COMMISSION REGULATION (EU) 2018/1832

of 5 November 2018

amending Directive 2007/46/EC of the European Parliament and of the
Council, Commission Regulation (EC) No 692/2008 and Commission
Regulation (EU) 2017/1151 for the purpose of improving the emission type
approval tests and procedures for light passenger and commercial vehicles,
including those for in-service conformity and real-driving emissions and
introducing devices for monitoring the consumption of fuel and electric energy

(iii)     in point 2.3., Figure A8.App6/1 is replaced by the following:

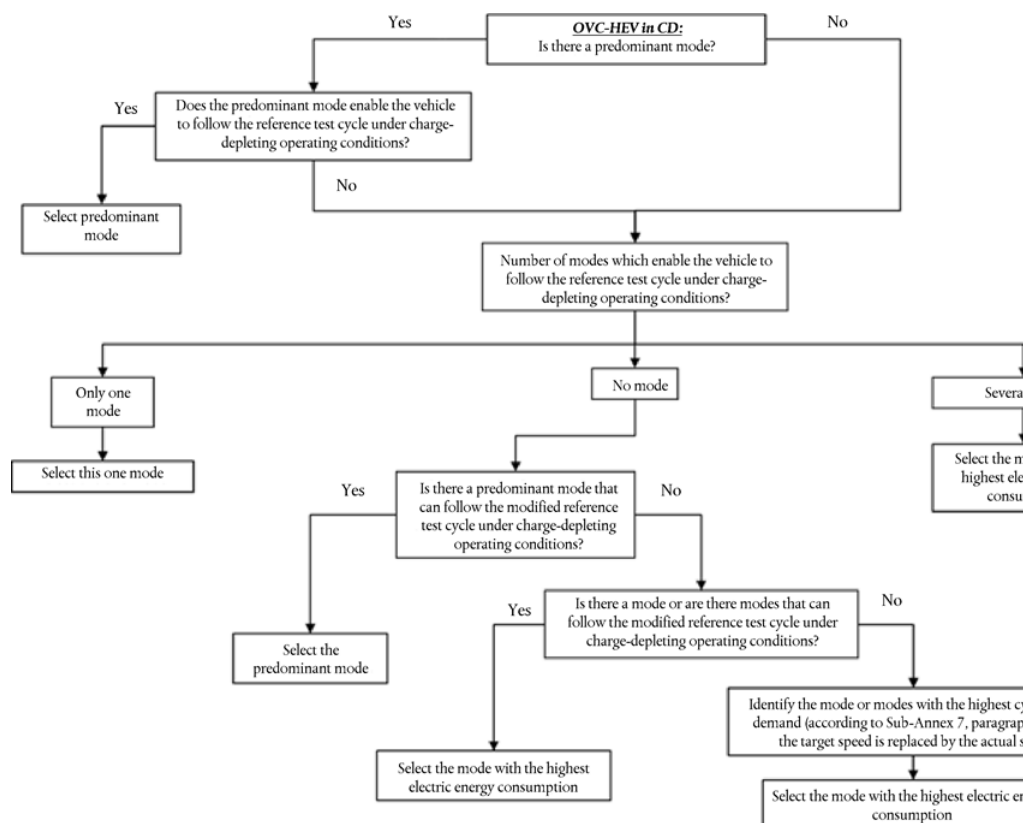
The flow chart in Figure A8.App6/1 illustrates the mode selection in accordance with this paragraph.

*Figure A8.App6/2* **Selection of a driver-selectable mode for OVC-HEVs, NOVC-HEVs and NOVC- FCHVs under charge-sustaining operating condition**

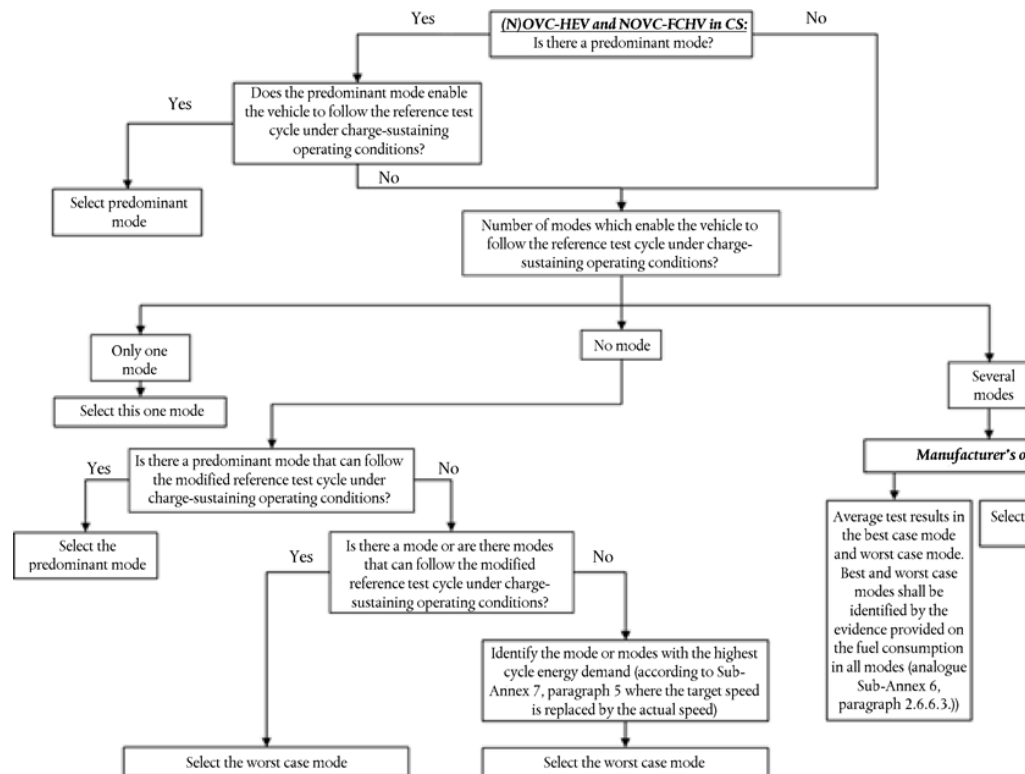
The flow chart in Figure A8.App6/2 illustrates the mode selection in accordance with this paragraph.

(v)        in point 3.3., Figure A8.App6/2 is replaced by the following:

*Figure A8.App6/3* **Selection of the driver-selectable mode for PEVs**

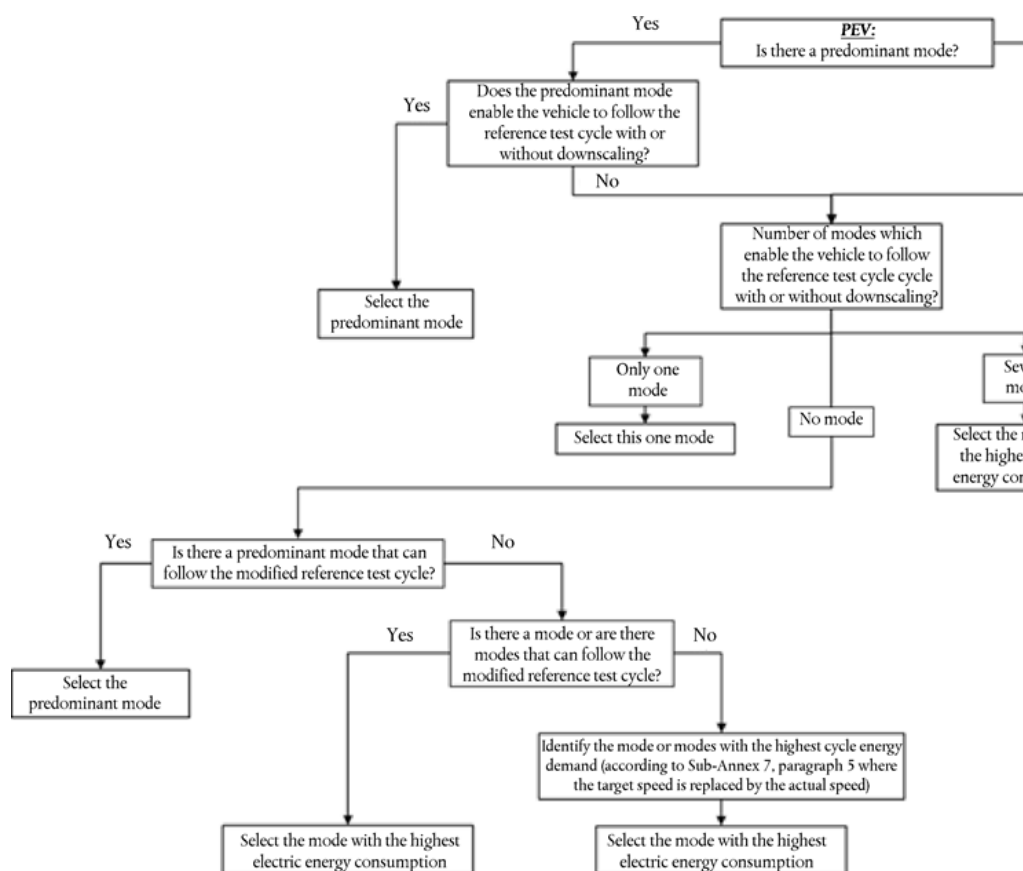
The flow chart in Figure A8.App6/3 illustrates the mode selection in accordance with this paragraph.

(vii)      in point 4.3., Figure A8.App6/3 is replaced by the following:
